AP1000 CONTAINMENT VESSEL EXTERNAL PRESSURE ANALYSIS AND DESIGN

NRC REVIEW PACKAGE

FIGURE 1: PROPOSED VACUUM RELIEF SYSTEM SKETCH

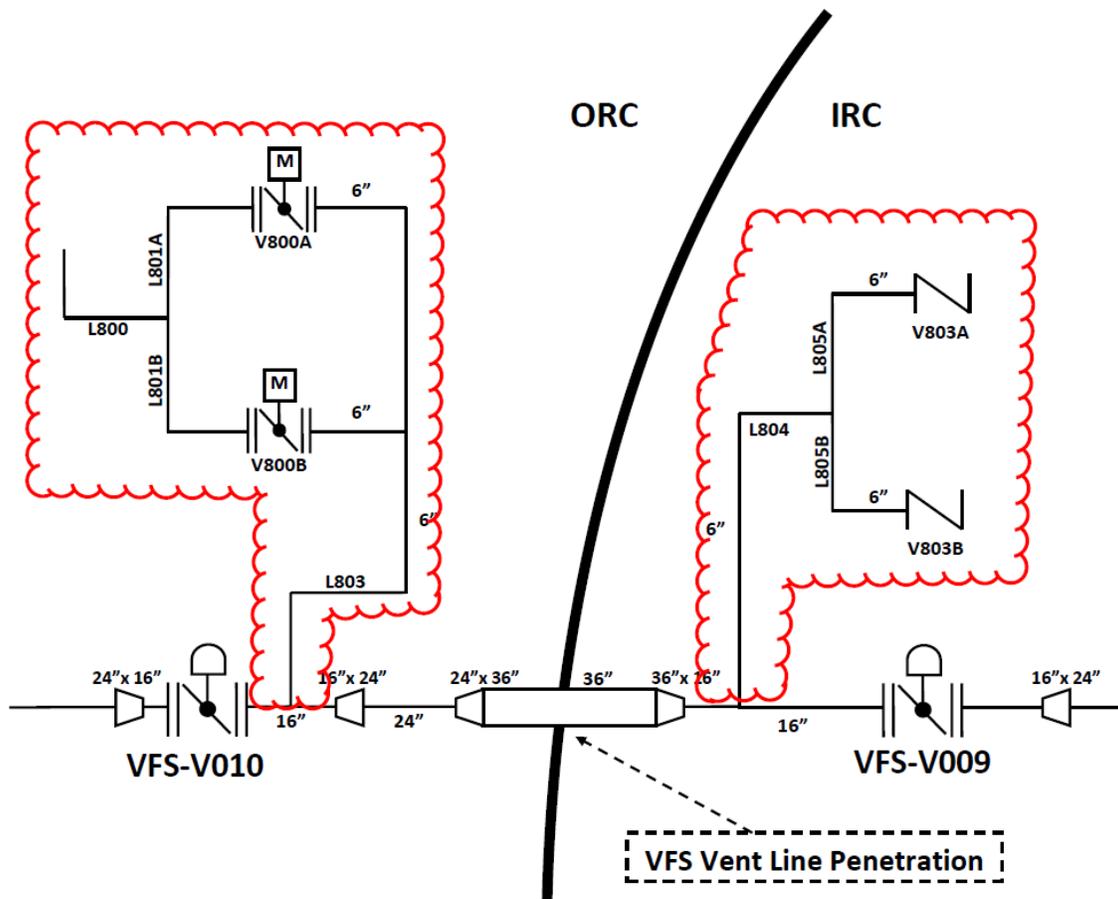
The proposed vacuum relief system consists of two vacuum relief lines sized to prevent differential pressure between containment and the shield building from exceeding the design value of 1.5 psid.

Each relief line consists of a check valve inside containment (V803A/B) and motor operated butterfly valve (V800A/B) outside of containment. Each butterfly valve operator is powered from separate IE DC battery sources. The check valves are balanced to open at 0.5 psi differential but will not open until the butterfly valves open.

The proposed change adds a Vacuum Relief System to the existing Containment Air Filtration System (VFS) vent line penetration as seen in the sketch below. The vent line was selected to provide enough flow area as well as the fact that in normal Purge and Vent operation the vent line will be under a slight negative pressure (vacuum system check valves will tend to close) and not short cycle the normal containment air flow when the Purge/Vent system is in operation.

DCD Tier 1 Figure
2.2.1-1 Markup

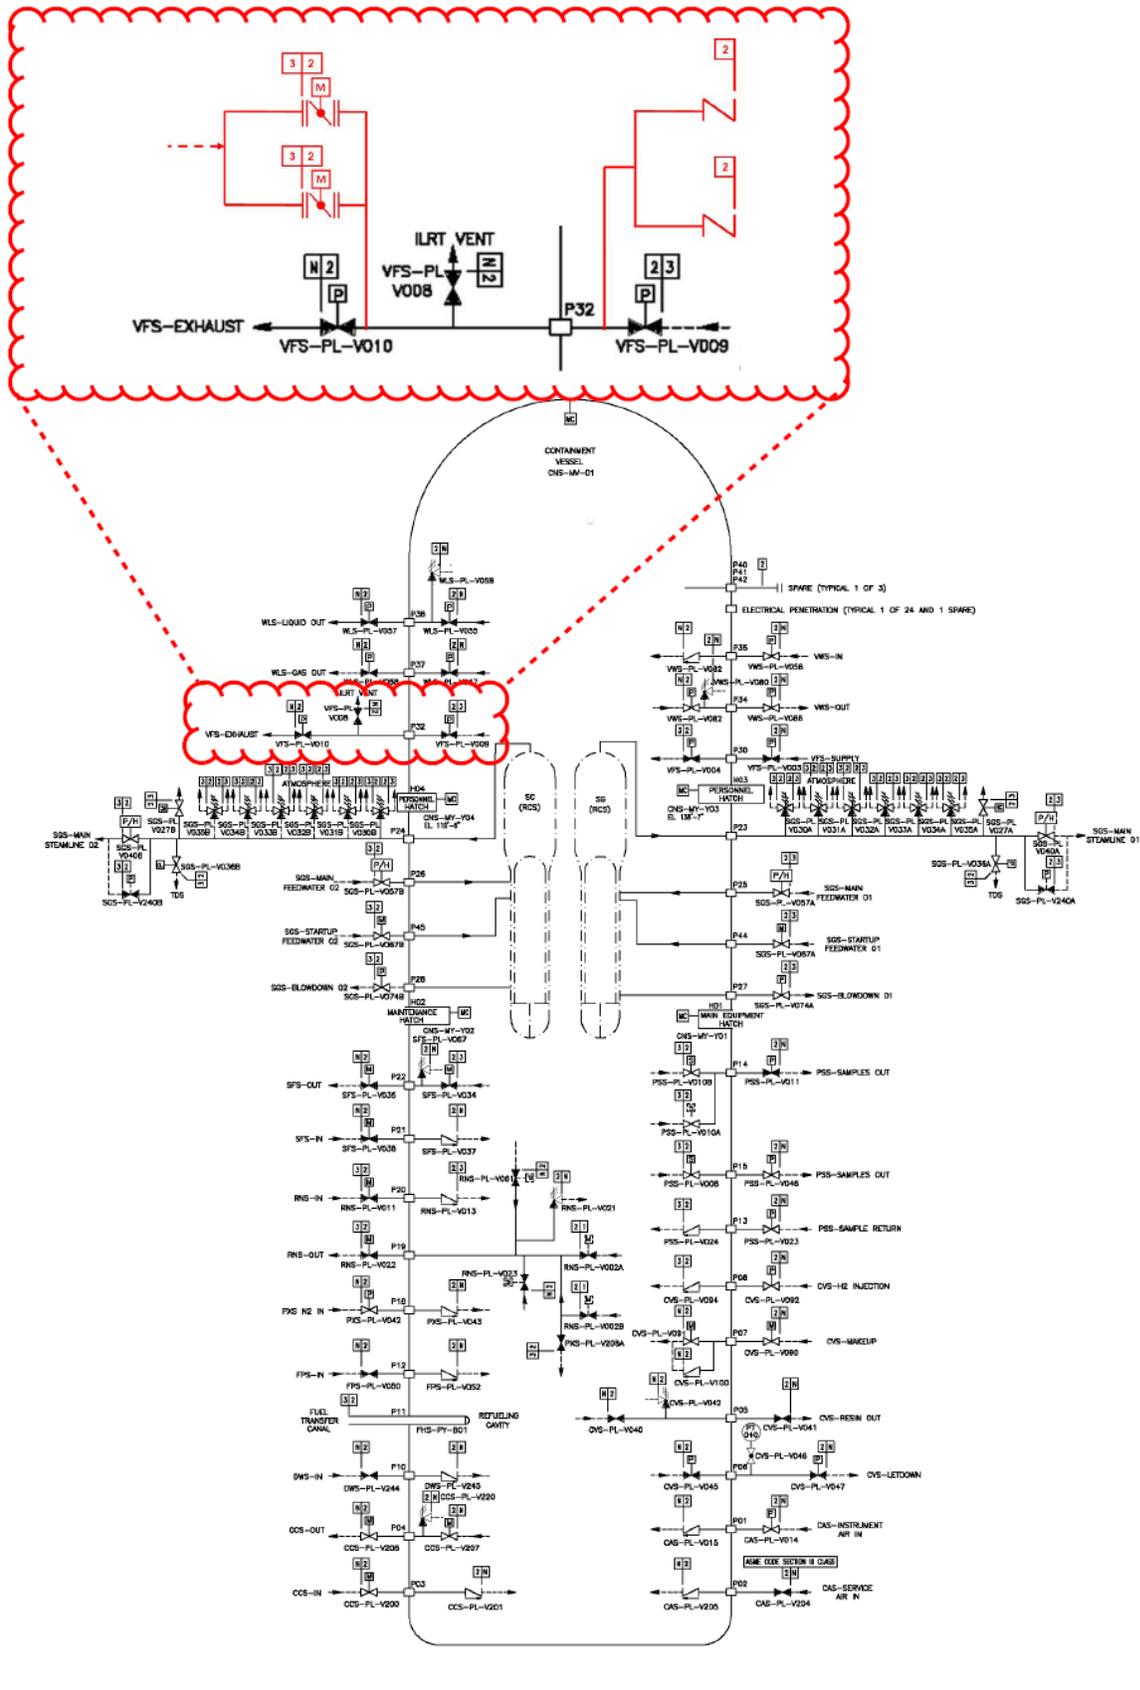
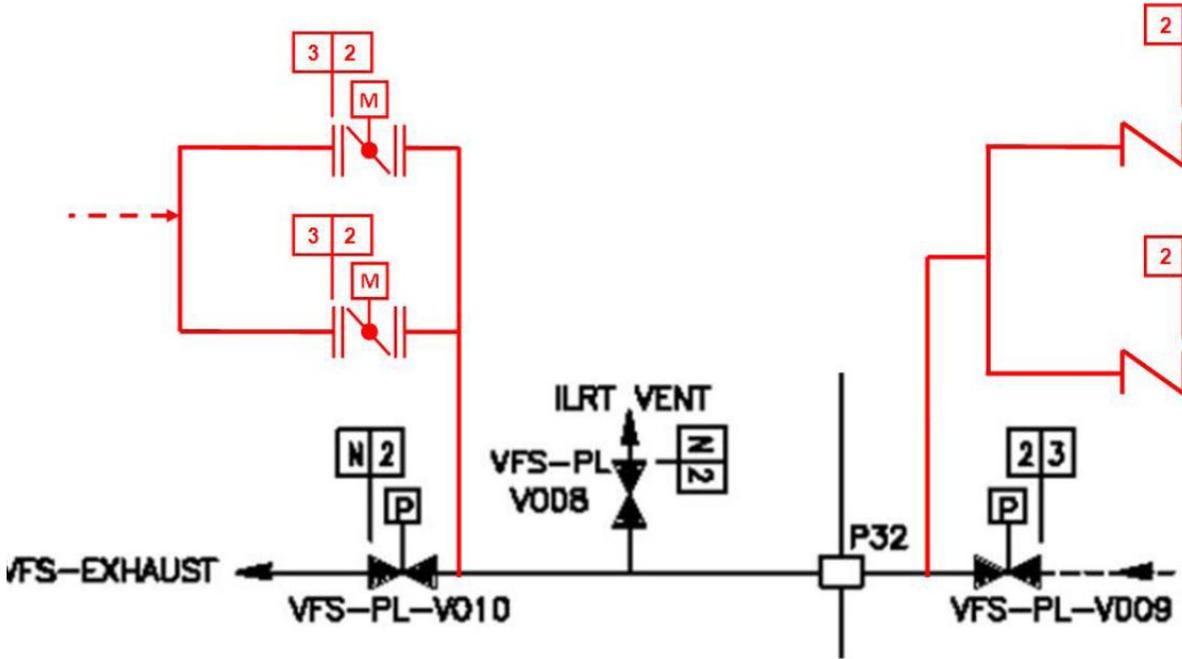
Att.	DCD	Title	Reason for Change
Tier 1			
1	Table 2.2.1-1	Containment System	Valves VFS-V800A/B and VFS-V803A/B have been added to the Containment System equipment table. The valves are indicated with active functions to Transfer Closed and Transfer Open.
2	Figure 2.2.1-1	Containment System	The proposed vacuum relief system has been added to the Containment System figure on the vent line penetration (Penetration #32). In addition the piping upstream of VFS-V009.
3	Table 2.2.1-2	Containment System Piping	Line numbers L800, L801A/B, L803, L804, and L805A/B have been added to the Containment System safety related line number list.
4	Text 2.7.6	Containment Air Filtration System	The proposed Vacuum Relief System safety function was added to the Containment Air Filtration System Safety Function description.
5	Table 2.7.6-2	Inspections, Tests, Analyses, and Associated Criteria (ITAAC) Table for the VFS	The proposed Vacuum Relief System safety function was added to the Containment Air Filtration System ITAAC Table description.

DCD Figure 6.2.1.1-11 (New)

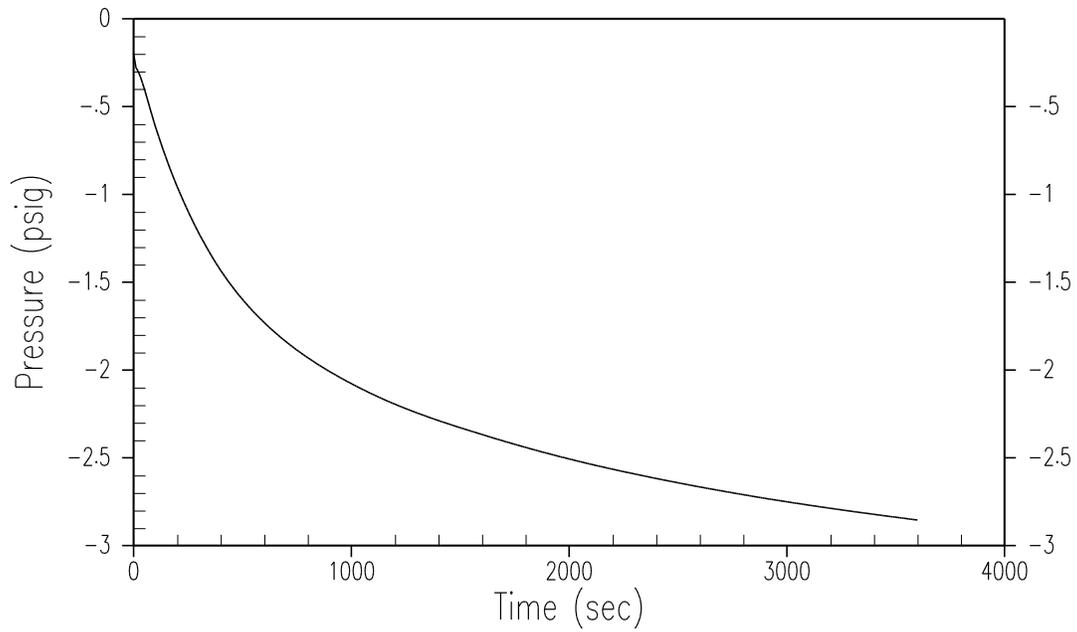
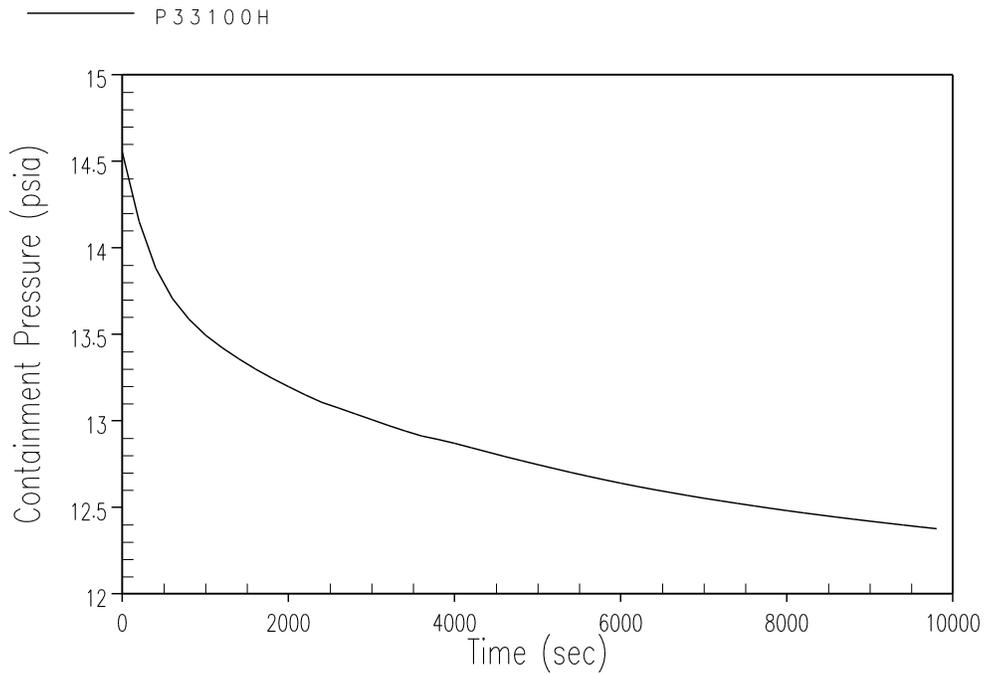
17	Text 6.2.1.1.4/ Figure 6.2.1.1.-11/ Table 6.2.1.1-9	External Pressure Analysis	This text defines the containment pressure transient that forms the basis for sizing the vacuum relief system. Previously, this text had been incorrect as it credited IE batteries to open the containment ventilation purge isolation valves to mitigate a low containment pressure event. The text has been changed to reflect the revised analysis inputs, assumptions and containment pressure transient response. Using the results of this analysis, the vacuum relief system was sized to mitigate containment internal pressure from dropping below -1.5 psig.
			Figure 6.2.1.1-11 has been revised to reflect the new containment pressure transient analysis.
			New table 6.2.1.1-9 was added to list key parameters and assumptions used in the transient analysis.
18	Figure 7.2-1 (Sheet 13 of 20)	AP1000 Functional Diagram Containment and Other Protection	This figure has been updated to identify the signals for actuating the containment vacuum relief isolation valves. The following signals will OPEN the Containment Isolation Relief valves: a 2004 "Low-2 Containment Pressure", or one of two manual actuation controls. The following signals will CLOSE the Containment Isolation Relief valves: Safeguards (S) Actuation signal, High-1 Containment Radiation signal, or one-of-two manual actuation controls.

Certain design basis events and credible inadvertent systems actuation have the potential to result in containment external pressure loads. Evaluations of these events show that a loss of all ac power sources during ~~extreme~~ cold ambient conditions has the potential for creating the worst-case external pressure load on the containment vessel. This event leads to a reduction in the internal containment heat loads from the reactor coolant system and other active components, thus resulting in a temperature reduction within the containment and an accompanying pressure reduction. Evaluations are performed to determine the maximum external pressure to which the containment may be subjected during a postulated loss of all ac power sources for the purpose of designing the containment vacuum relief system.

The evaluations are performed with the assumption of a ~~-40~~ 33°F ambient temperature with ~~a steady 48 mph wind blowing to maximize cooling of the containment vessel no outside wind blowing to maximize the containment internal temperature and humidity.~~ The initial internal containment temperature is in equilibrium conservatively assumed to be at 120°F, creating the largest possible temperature differential to maximize the heat removal rate through the containment vessel wall. A negative 0.2 psig initial containment pressure is used for this evaluation. Containment internal humidity is conservatively assumed to be at 100%. ~~A conservative maximum initial containment relative humidity of 100 percent is used. to produce the greatest reduction in containment pressure due to the loss of steam partial pressure by condensation.~~ At transient initiation, the external wind is assumed to instantaneously accelerate to 48mph, and the external temperature is assumed to begin decreasing based on the form of a chopped cosine with minimum value of 13°F and periodicity of 24 hours. It is also conservatively assumed that no air leakage occurs into the containment during the transient. The key assumptions for heat transfer characteristics, containment initial conditions, and containment transient conditions are listed in Table 6.2.1.1-9.

Figure 7.2-1 (Sheet 13 of 20)

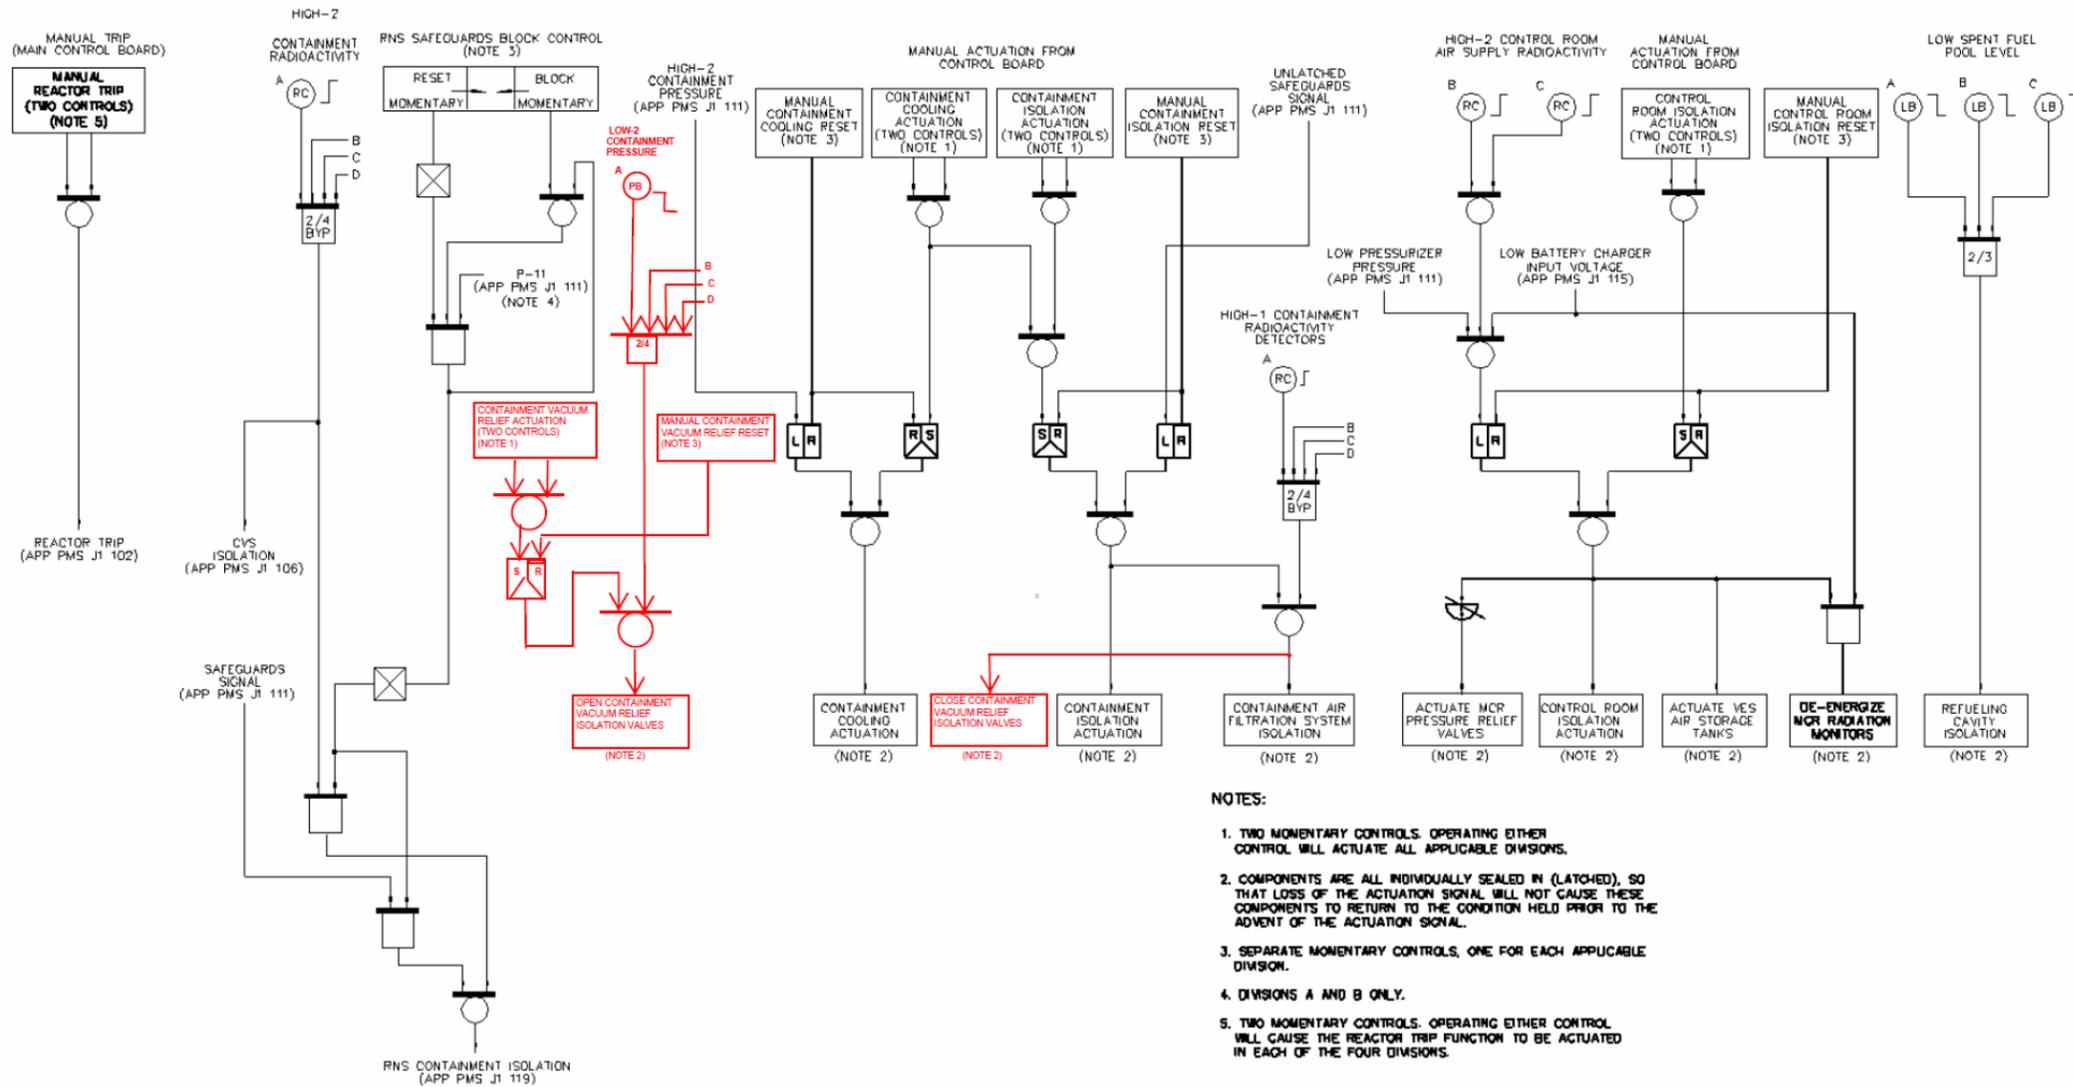
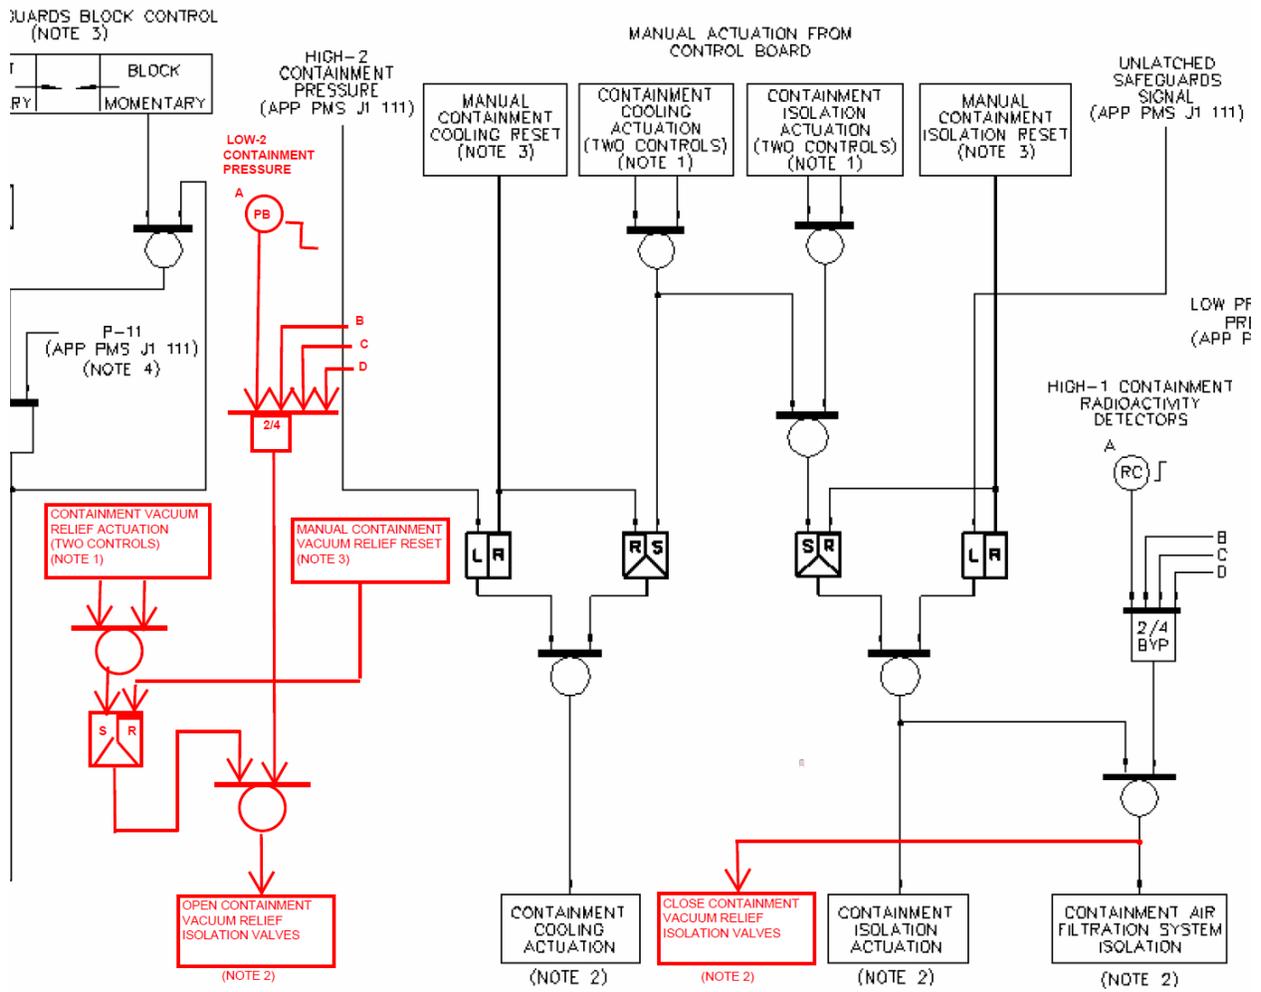
19	Table 7.3-1	Engineered Safety Features Actuation Signals	This table lists the actuation signals for safety related features. The containment vacuum relief system has been added to this table. Item 27 of this table lists the Containment Vacuum Relief signals. These signals are Low-2 Containment Pressure or Manual Initiation. No permissives or interlocks are required for any of these signals.
20	Text 7.3.1	Engineered Safety Features Description	This text has been updated to include Section 6.2 as a section that analyzes design basis events. The particular DCD paragraph is 6.2.1.1.4. DCD Chapter 15 contains the analyses of design basis events. Section 6.2 contains the analyses of the Containment only.
21	Text 7.3.1.2.25	Containment Vacuum Relief	DCD Section 7.3 describes the Engineered Safety Features. These features include "...providing containment integrity." The text of paragraph 7.3.1.2.25 describes the containment vacuum relief isolation actuation signal. It also gives a brief explanation of the high radiation, the high 2 containment pressure, and the manual initiation signals. This section has been added to explain the additions to Table 7.3-1.

The functional logic relating to containment vacuum relief is illustrated in Figure 7.2-1, sheet 13.
